ALLENDALE CHARTER TOWNSHIP
PLANNING COMMISSION MEETING

RE: Miedema Metal Building Systems - 4900 Allen Park
Site Plan Revision for Planning Commission Review

To: Allendale Charter Township Planning Commission
From: Gregory L. Ransford, MPA
Date: April 15, 2026
Re: 4900 Allen Park Site Plan Review Application – Preliminary Review

To: Allendale Charter Township Planning Commission
From: Gregory L. Ransford, MPA
Date: April 15, 2026
Re: Wesco Special Use Application – Preliminary Review

SHEET NUMBER L-1

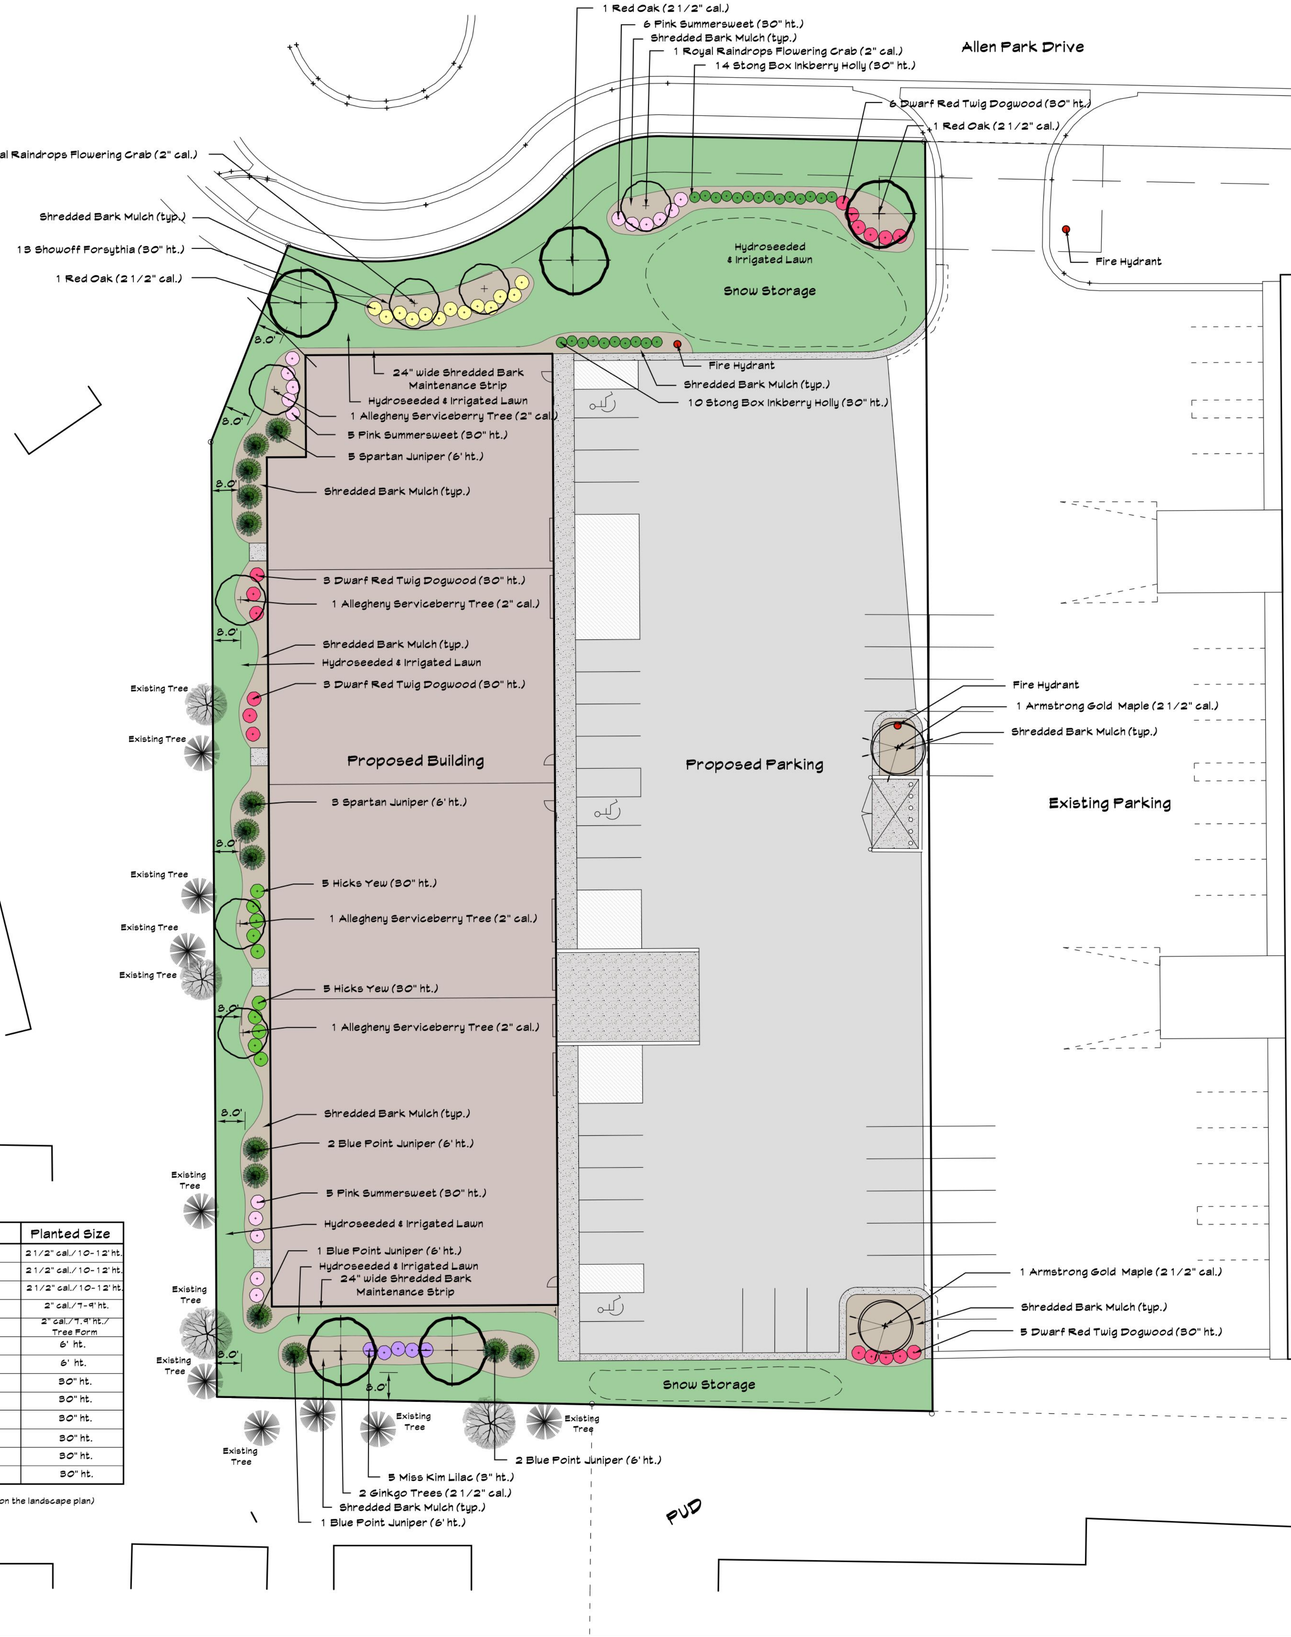
Pursuant to Section 470-21A.04A2 of the ACTZO, the west and south property lines are required to contain a greenbelt. Further, pursuant to Section 470-21A.04D1, that greenbelt shall be a minimum width of 15 feet and shall be setback at least eight feet from the property line. As you will note on the landscape plan, Sheet Number

L-1, while the west greenbelt is setback the required eight feet from the property line, given the proposed position of the building only seven feet is left for the required 15 feet of greenbelt. The south greenbelt illustrates compliance with this setback and minimum width requirement. While we directed the applicant to correct this greenbelt accordingly, they contend the grass is part of the greenbelt and the totality of 15 feet is therefore provided. While grass could be included in the 15 feet, we do not believe that is the spirit of the language nor do we believe the Planning Commission has even approved grass for this purpose. The Planning Commission will need to determine the extent of compliance or lack of compliance regarding the west greenbelt.

SITE DEVELOPMENT AND IMPROVEMENT PLAN

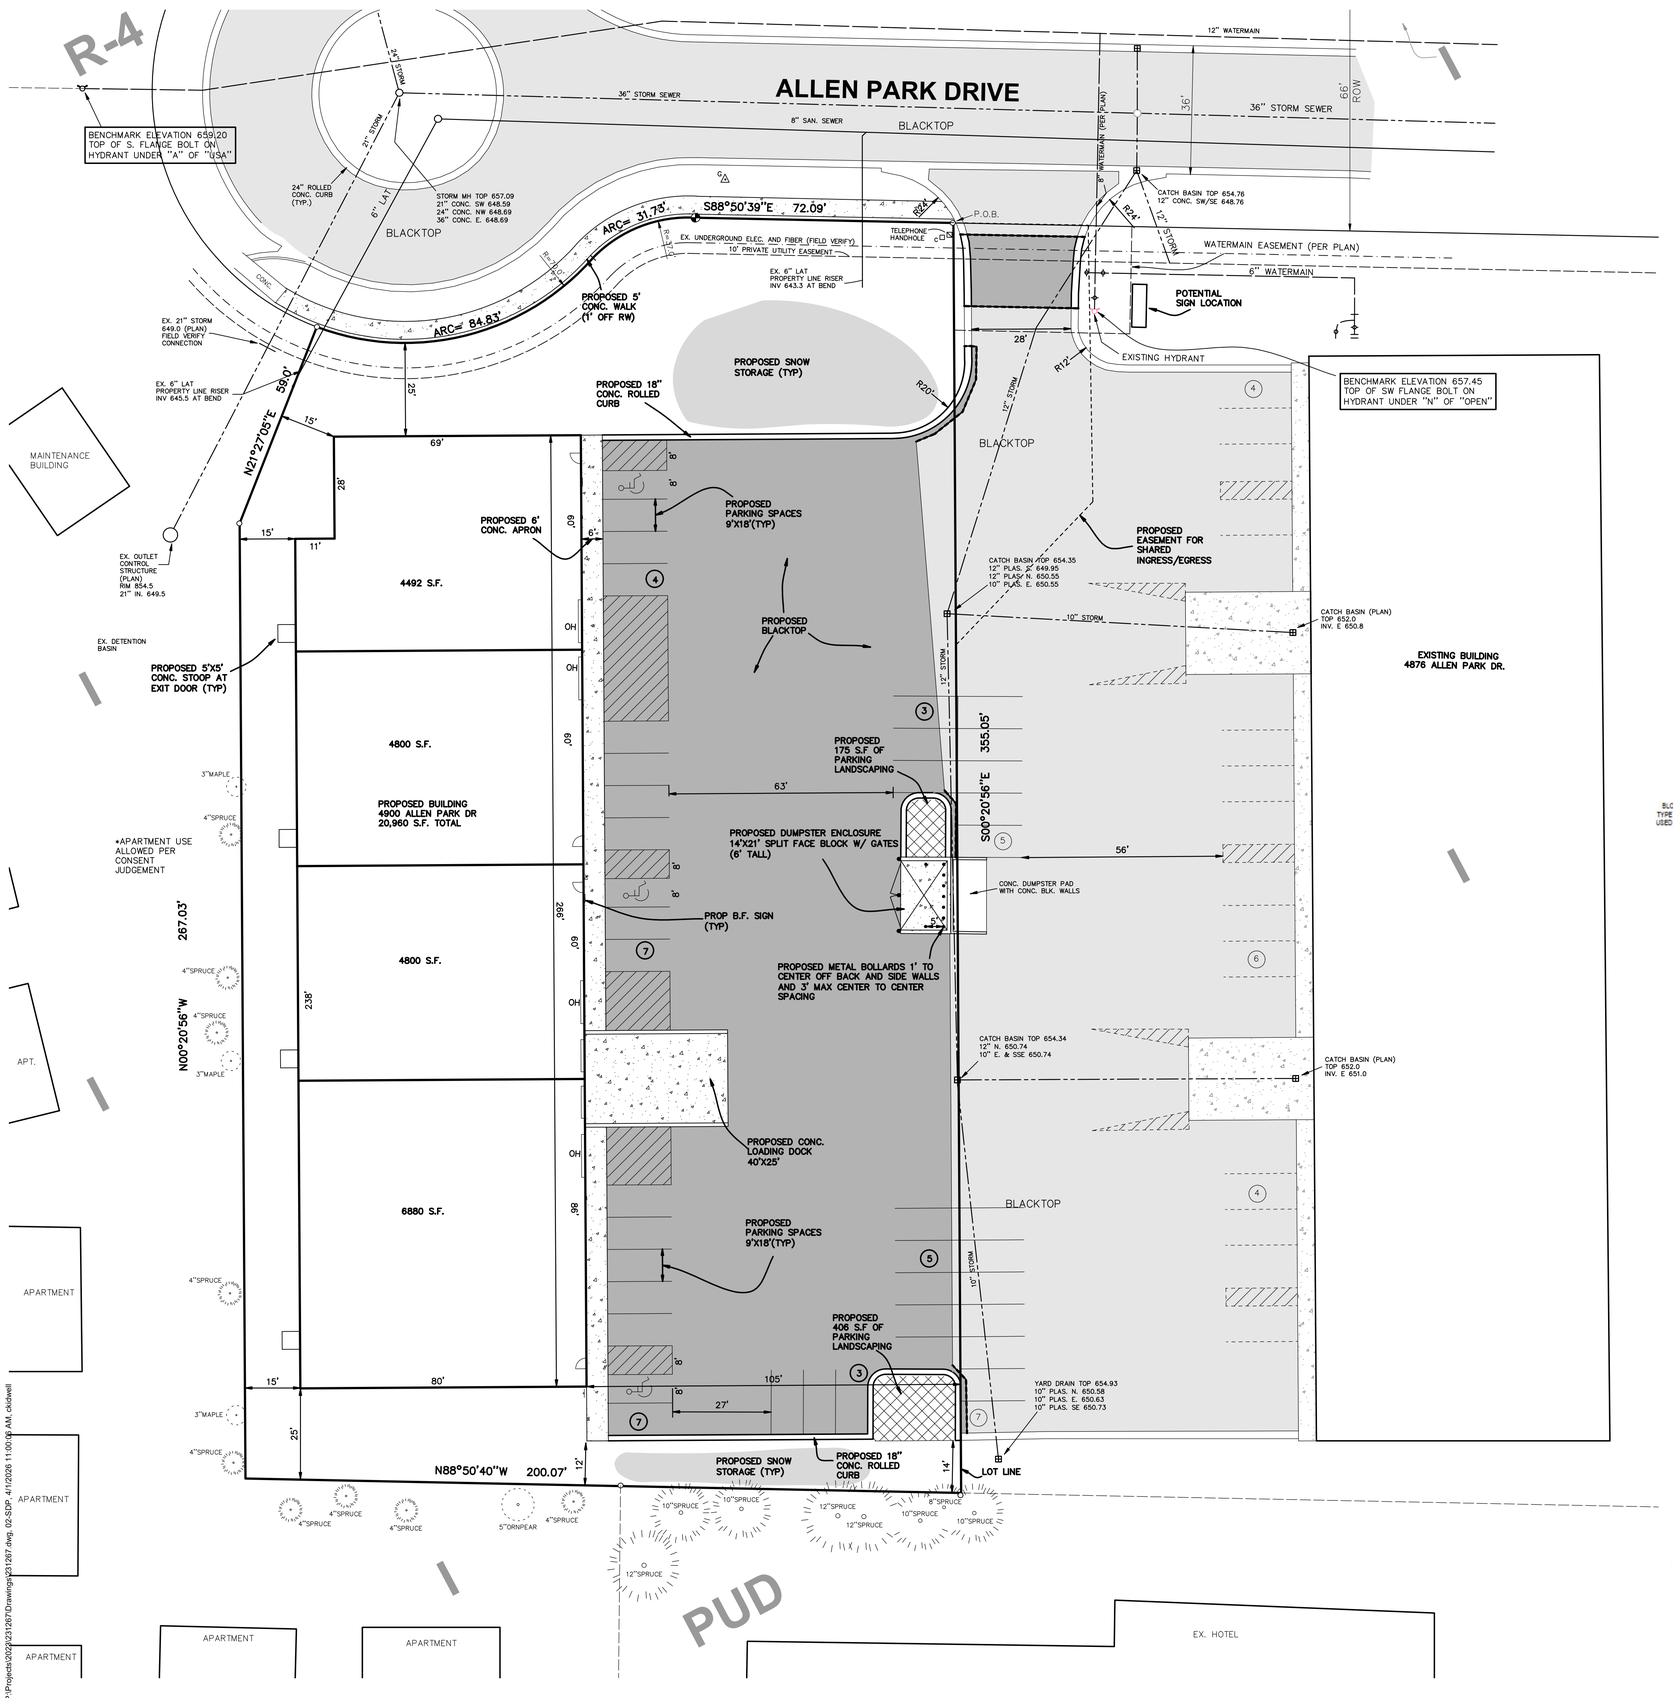
1. Site plan formatting should be updated to include the following items to help understand drainage patterns in the area:
    a. Extend contours to a distance of 50 feet outside the boundary lines of the site.

b. Show location and use of existing structures located within 100 feet of the site boundary.
2. Provide a small-scale sketch of properties, streets, and zoned uses of land within one-quarter mile of the site, sufficient to illustrate the existing character and development in the area of the site.

3. Provide the current zoning of all abutting properties.
4. Call out the turning radii for each turn to ensure fire trucks can make the turns.
5. Provide Allendale Charter Township specific details for water main and water service installation. This can be addressed during the construction plan development.

10. The proposed sidewalk does not appear to provide a continuous path to access the building. A revised configuration to improve accessibility may be considered.

SITE UTILITY PLAN

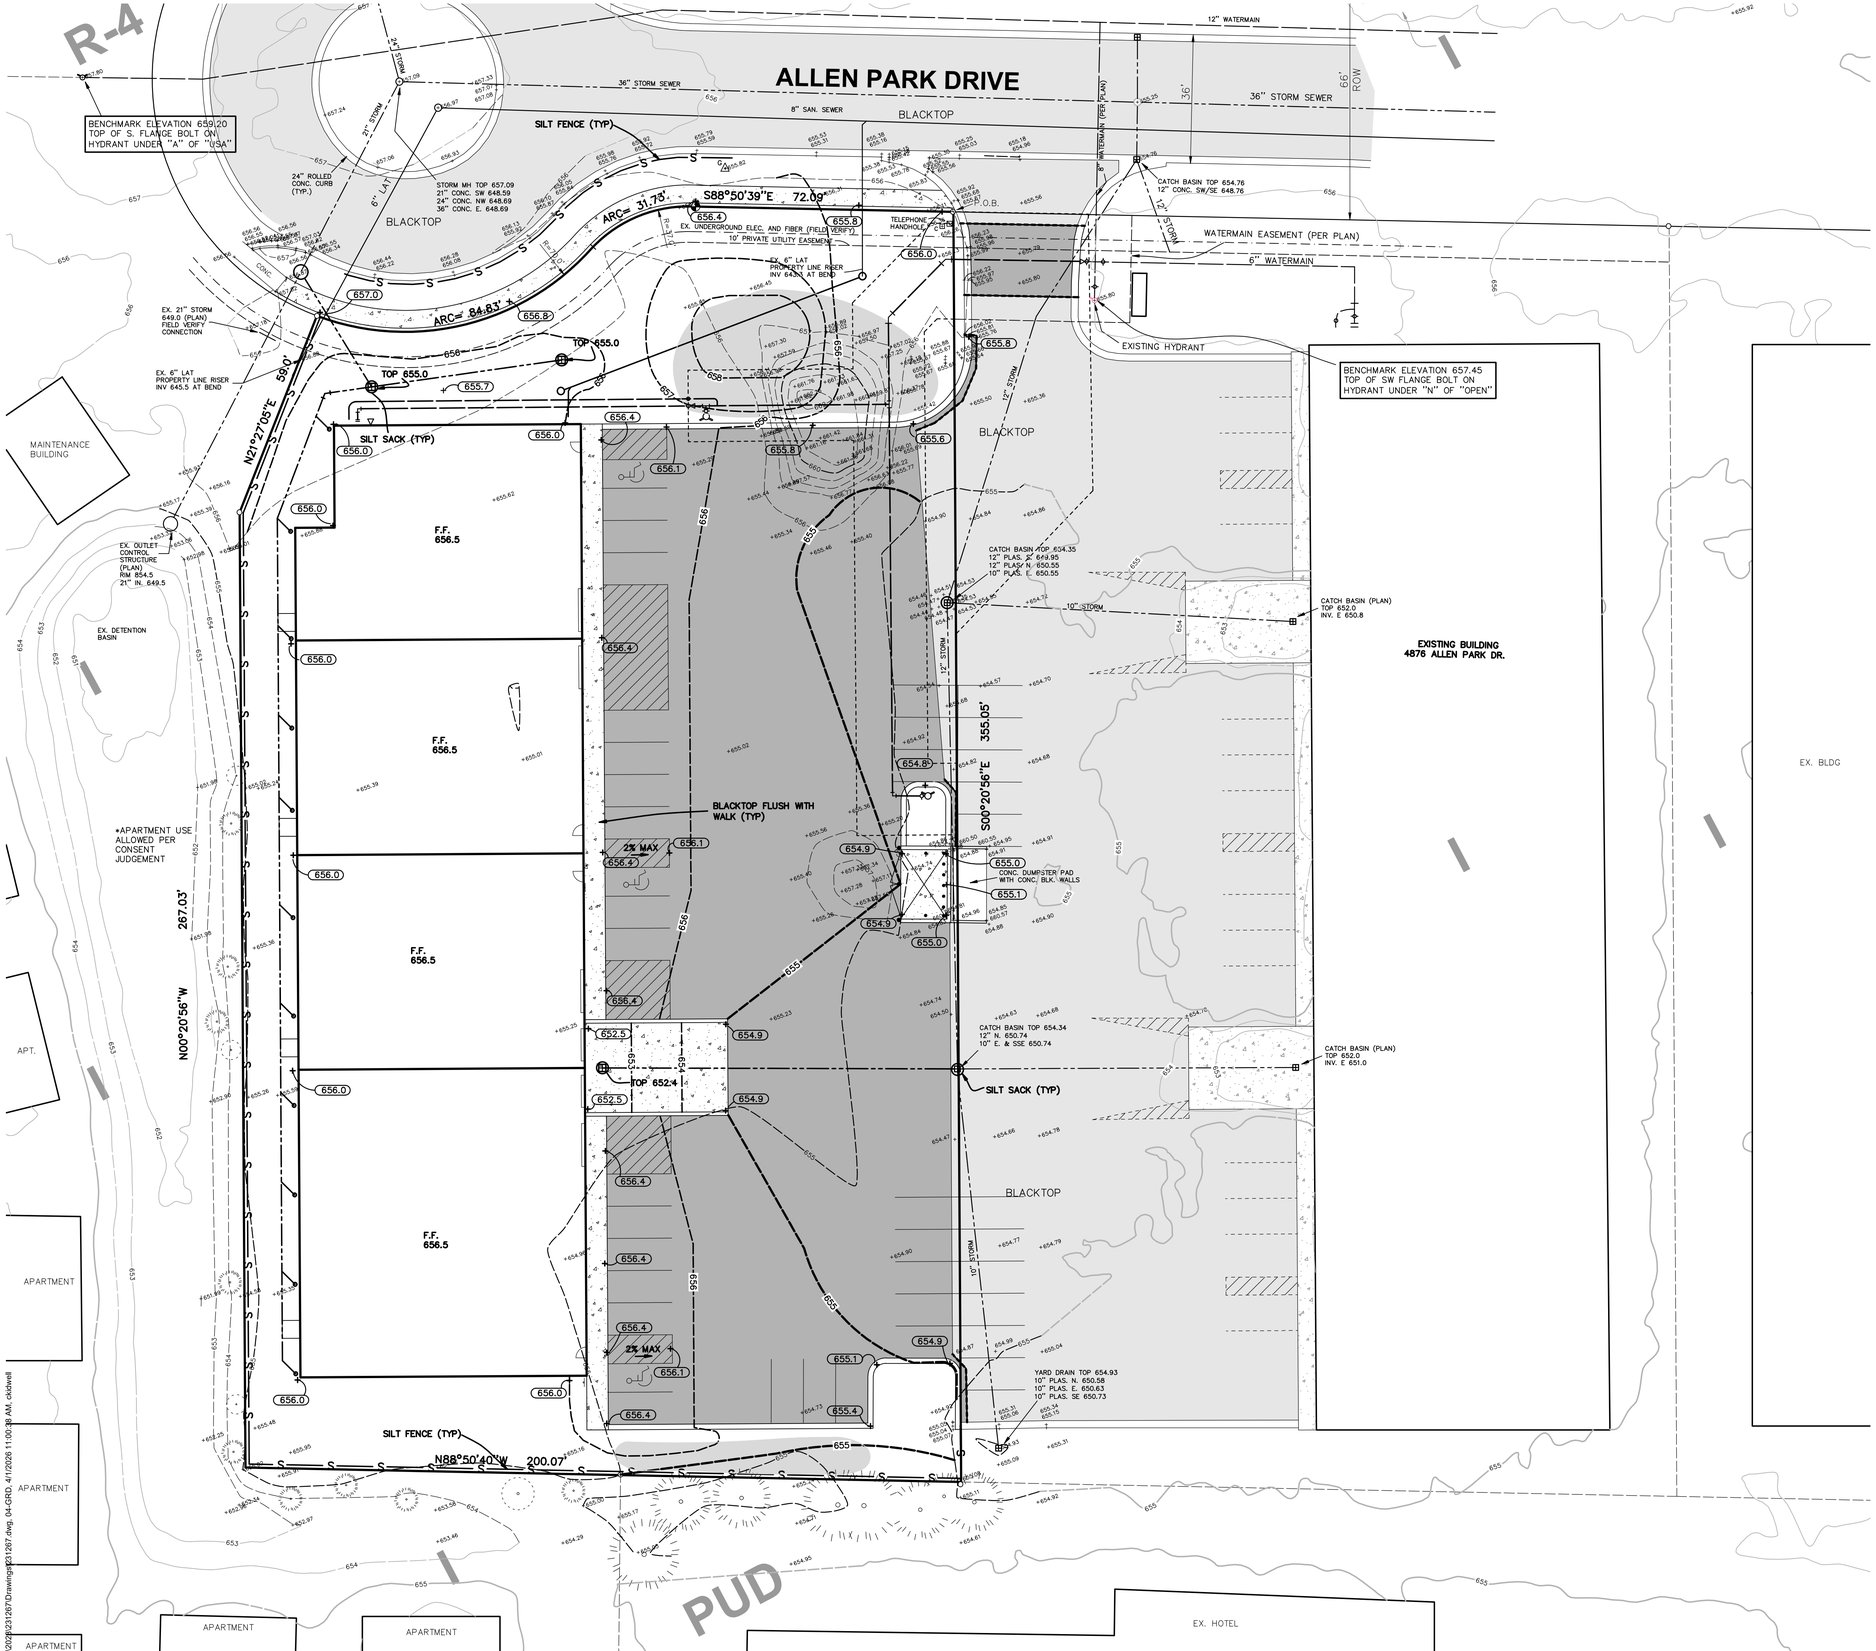
Site plan for 4900 Allen Park has been completed by Allendale Fire. Print has adequate access. There is not adequate hydrants to support the size of this building. There will need to be two fire hydrants added one at the entrance and one in the parking lot half way down the property. ***ICF2021Appendix C***

8. Provide verification of where the existing 21-inch storm sewer extends south at the Allen Park Drive roundabout. Does the existing 21-inch storm terminate here?

9. Provide verification that the proposed 4-foot storm manhole is adequately sized to accommodate the existing 21-inch storm sewer and the proposed 12-inch storm sewer. A larger manhole may be required to properly accommodate the storm sewers in the proposed layout.
